ADDENDUM #1

PROJECT NAME: SCCAD Headquarters

CLIENT NAME: St. Charles County Ambulance District

PROJECT NO.: 18007

F4 RR-2010 & 2009 - ENLARGED PLAN
 1/4" = 1'-0"

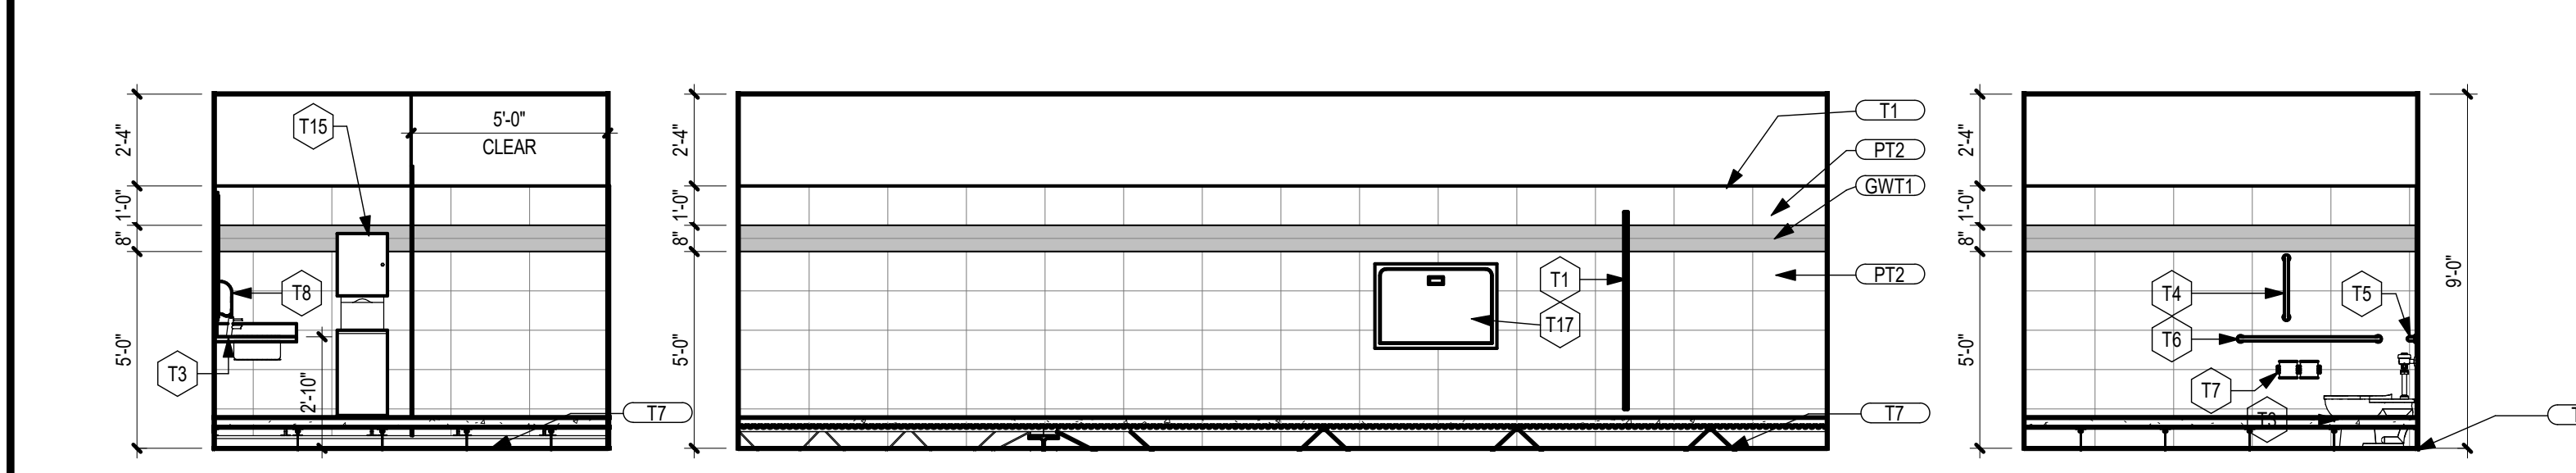
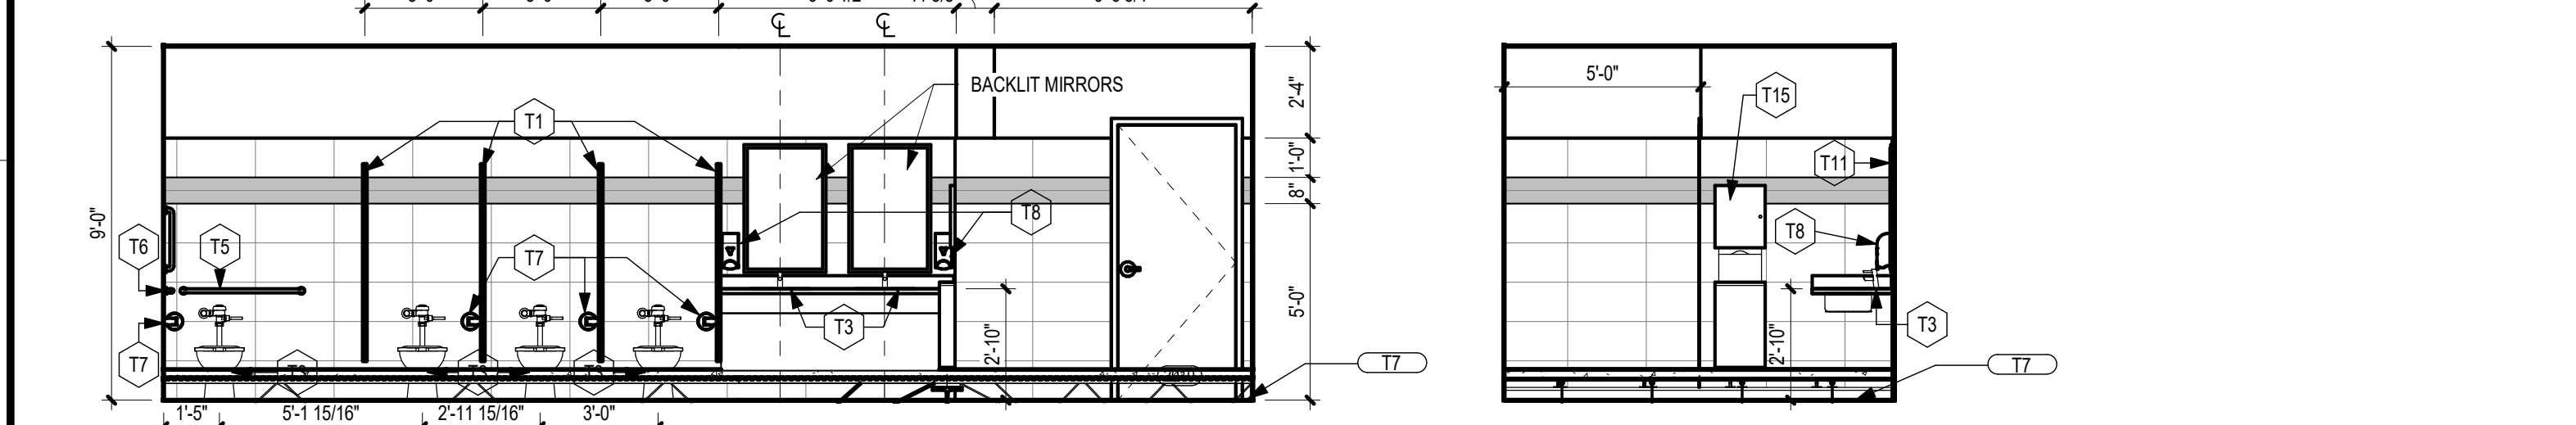
SHEET A423 – Toilet / Locker Plans & Elev.

1. ADD – Notes:

1 TYPICAL SLAB ON GRADE CONTROL JOINT DETAIL
 S103 / NTS

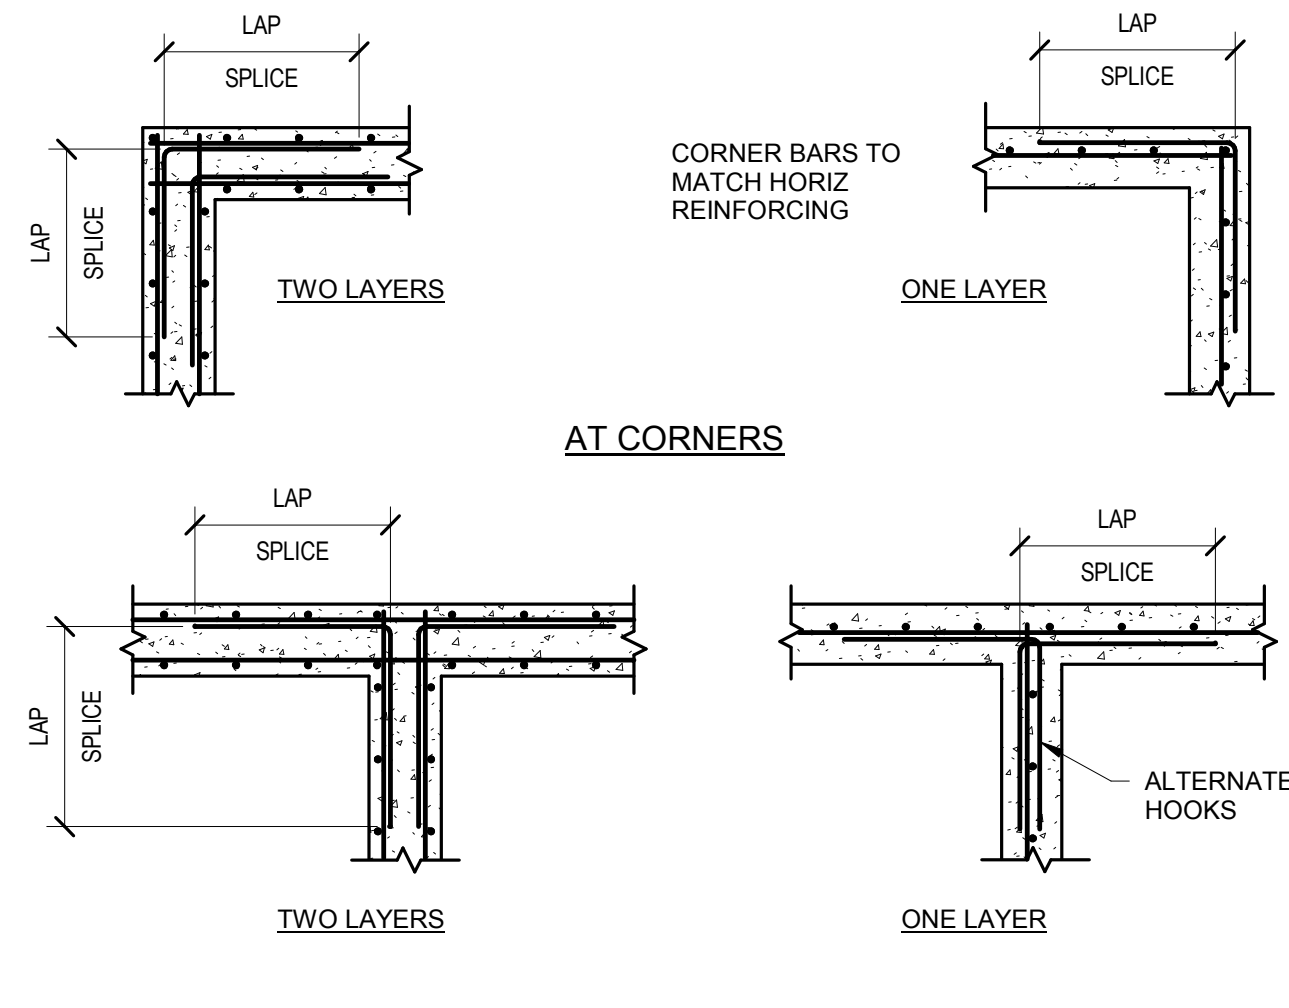
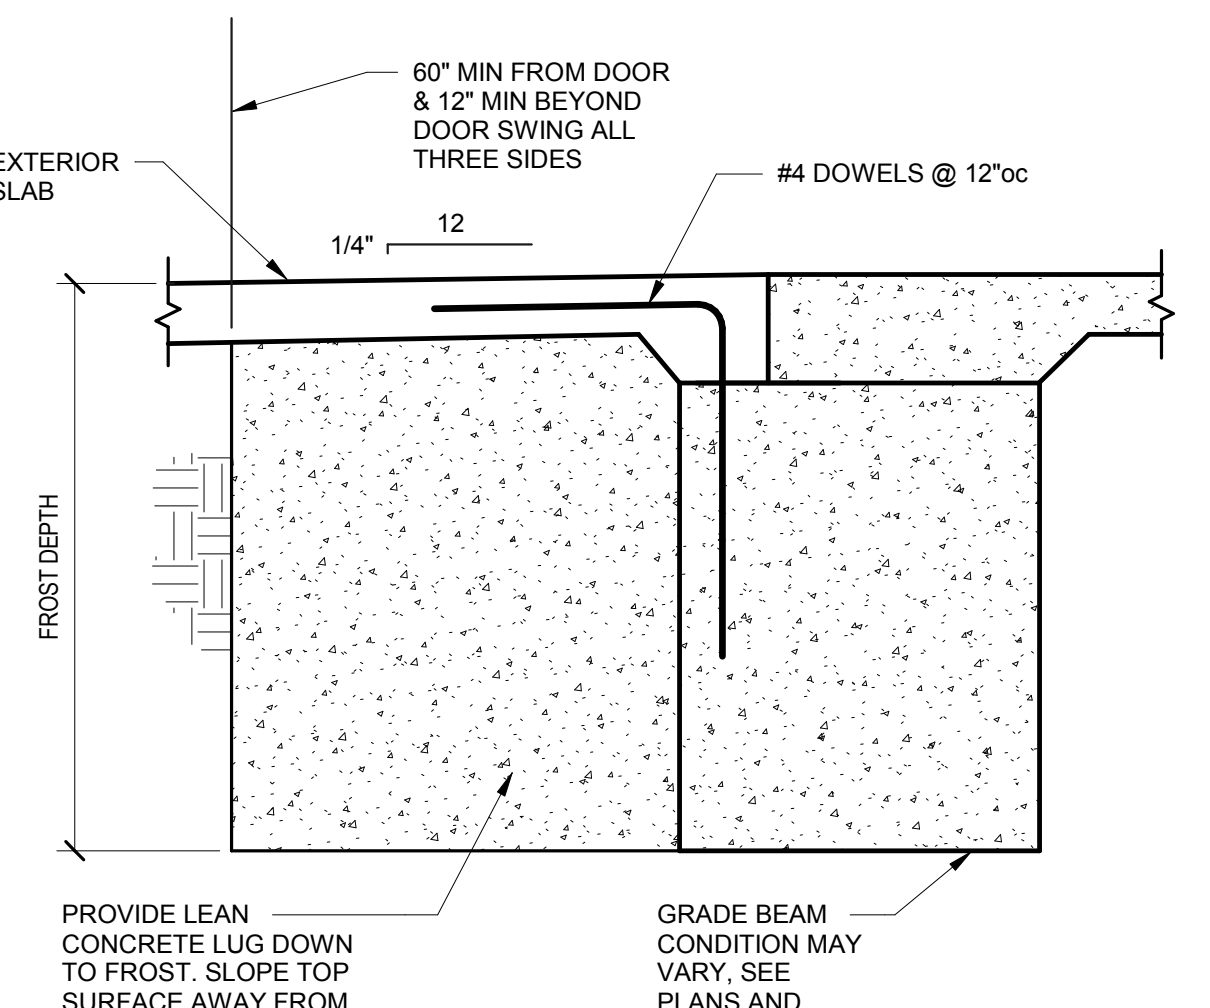
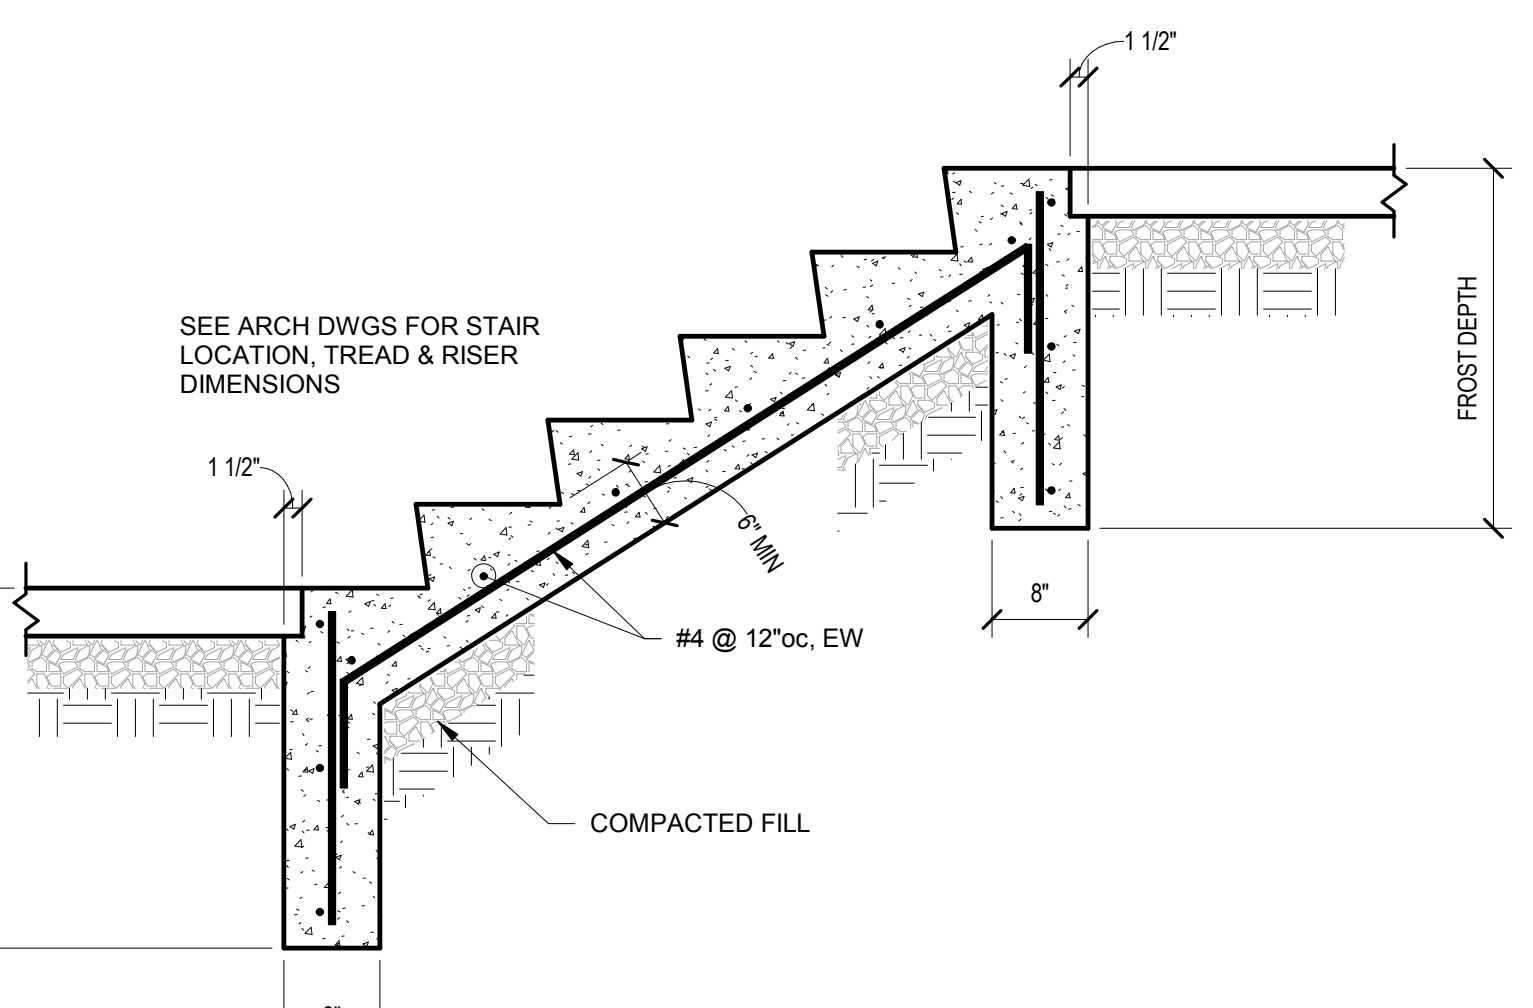
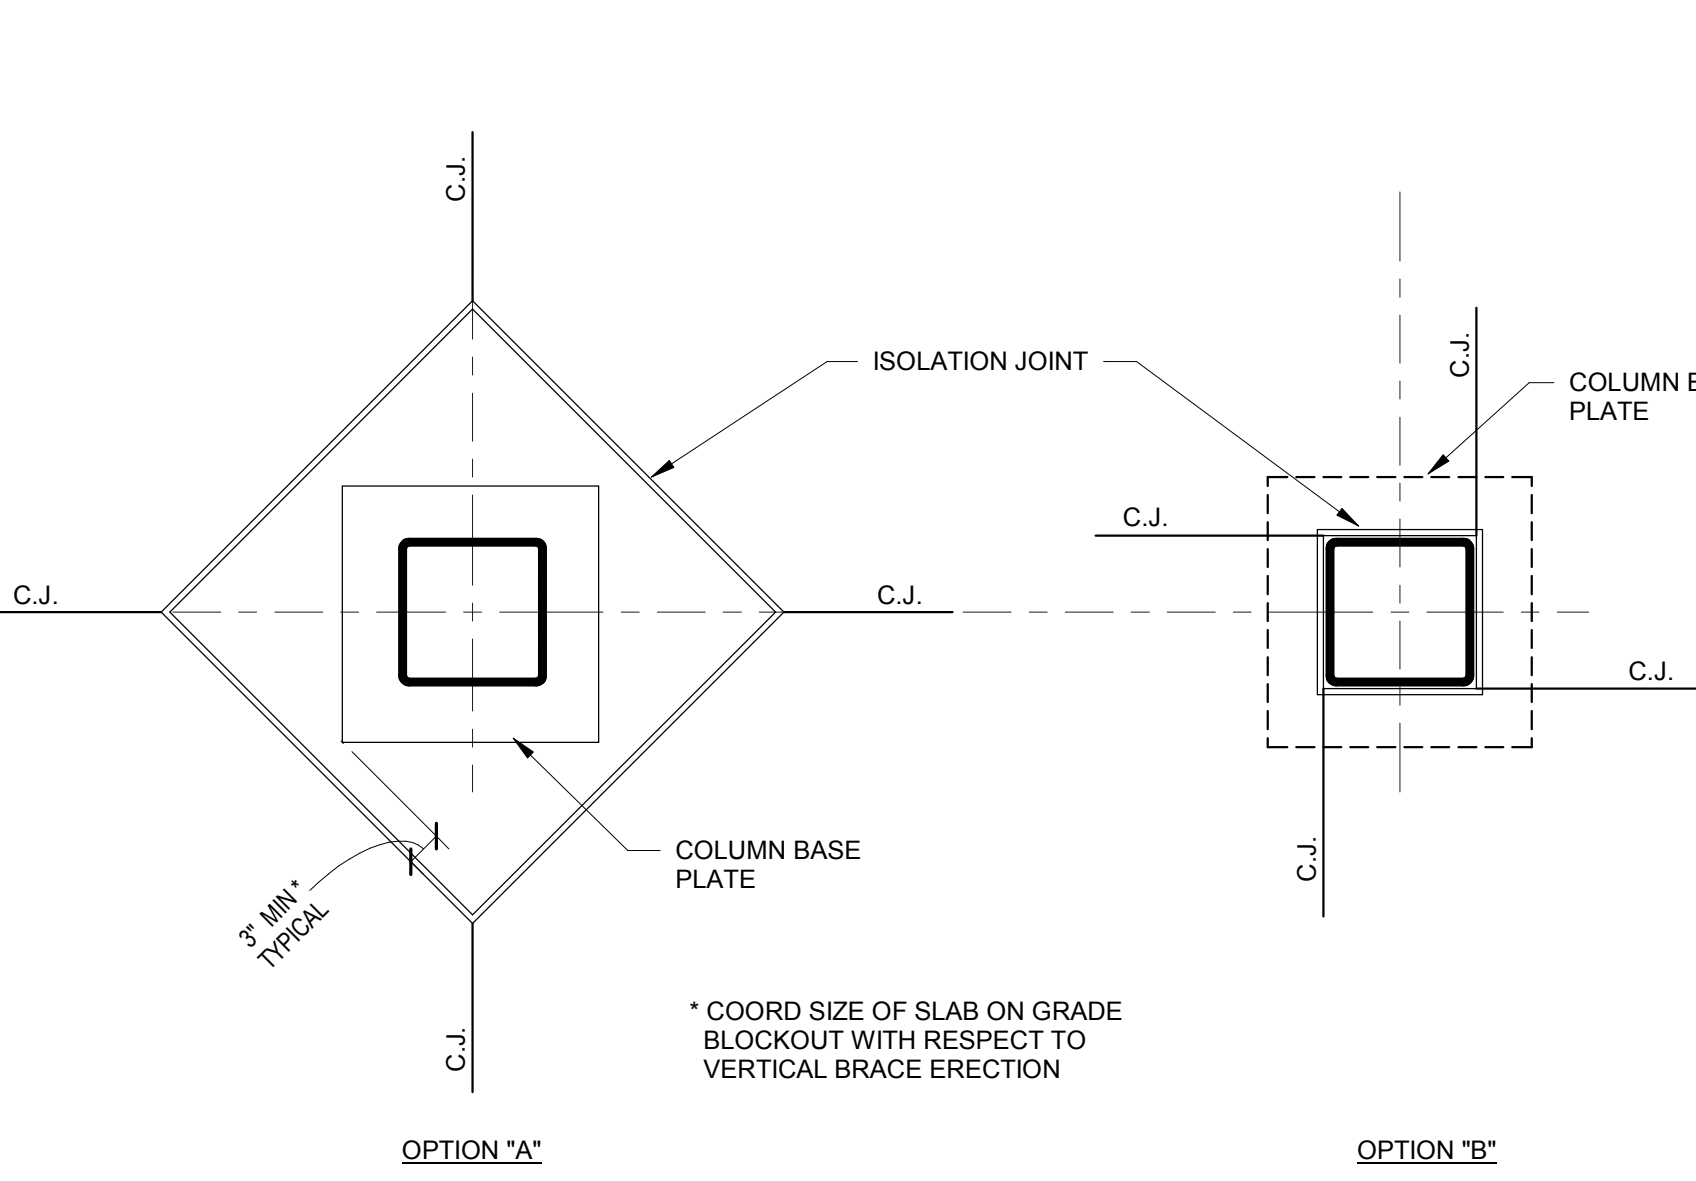
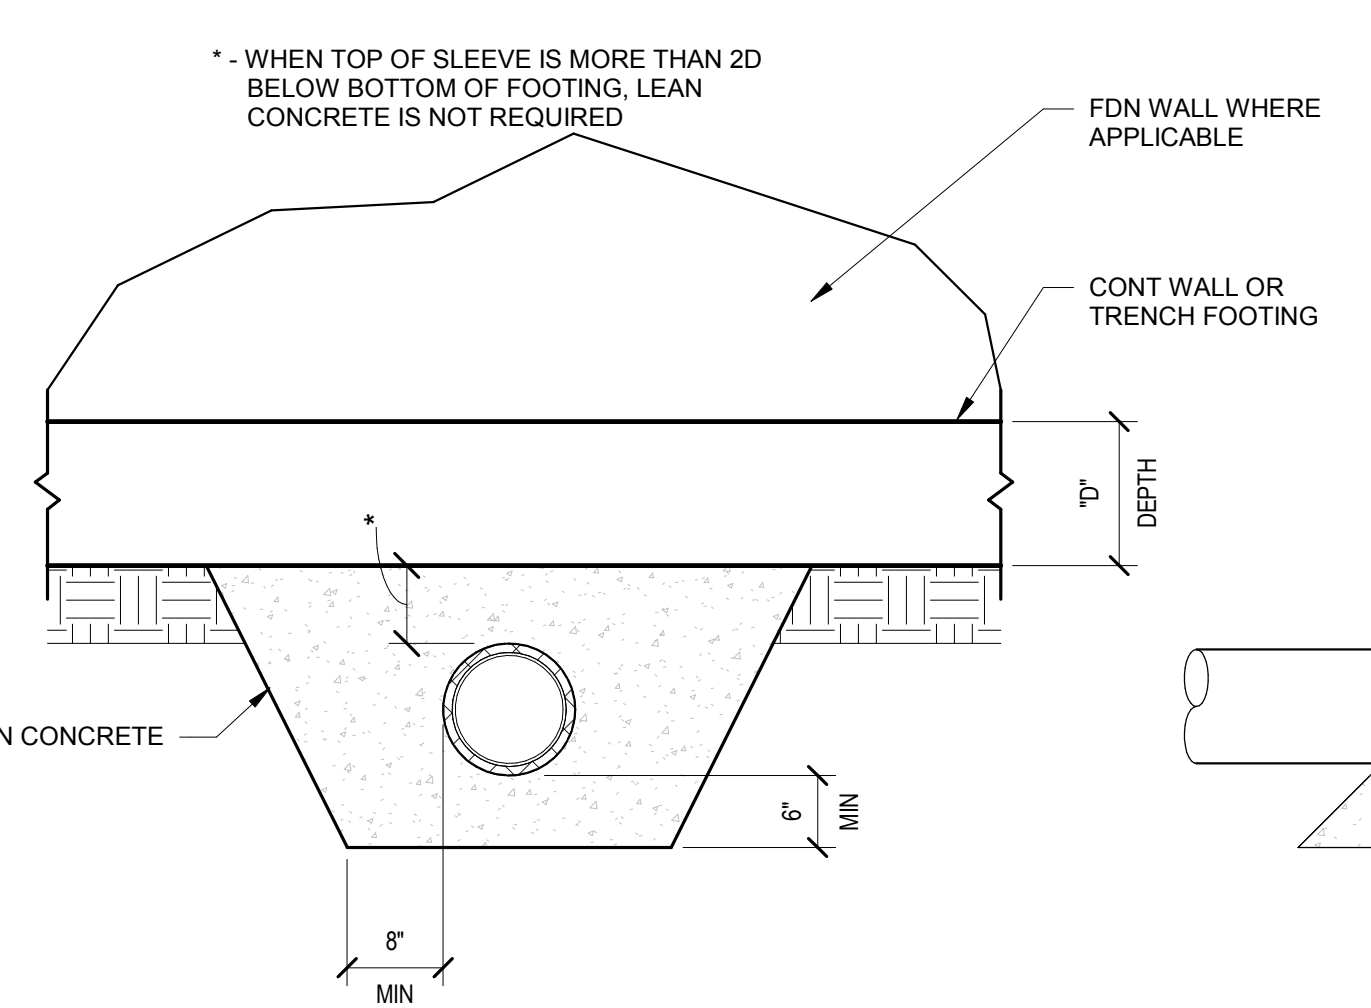
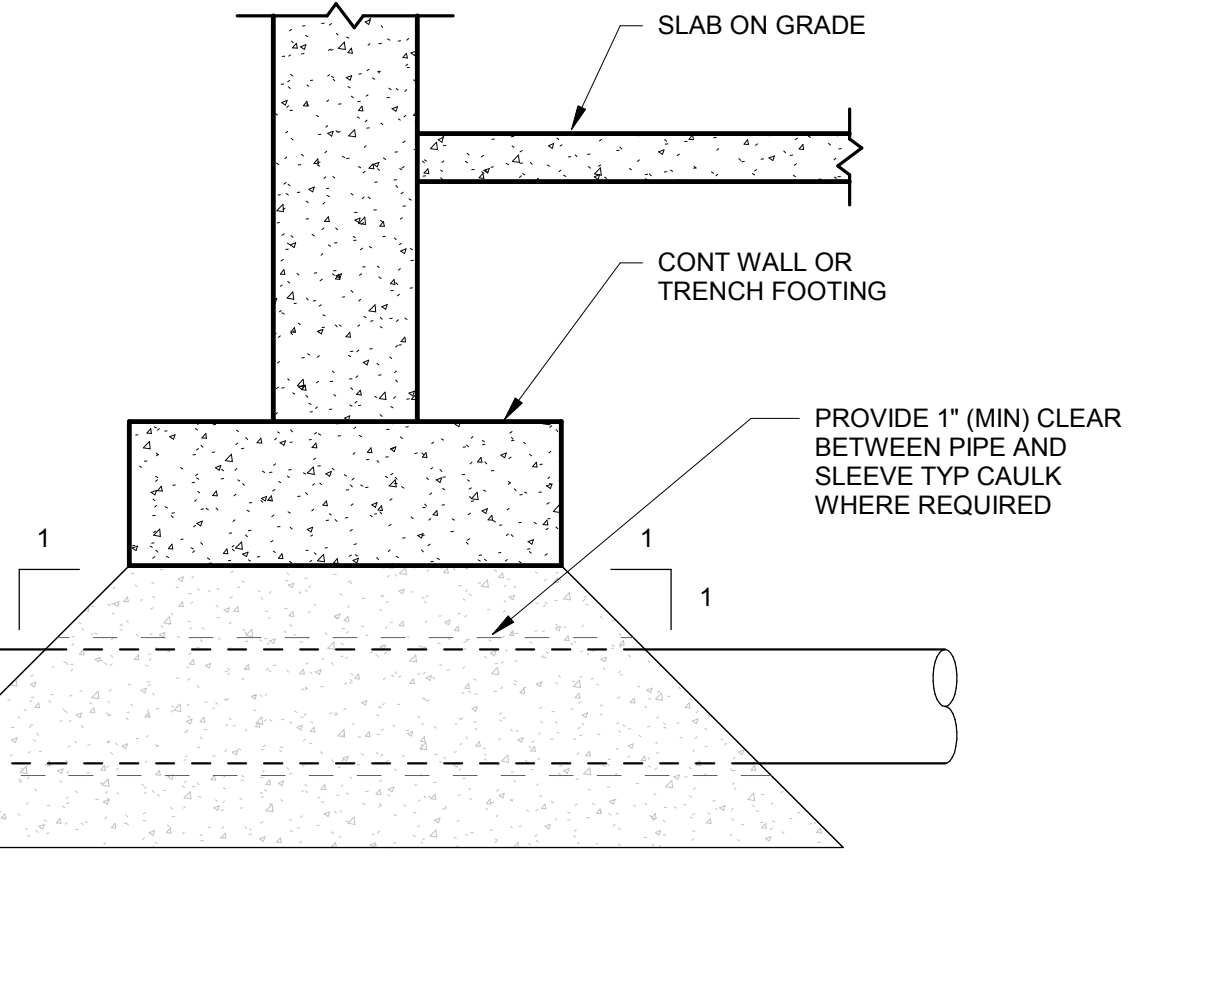
Sheet S103

- 4/S103 – Revised CMU partition base connection to post-installed.
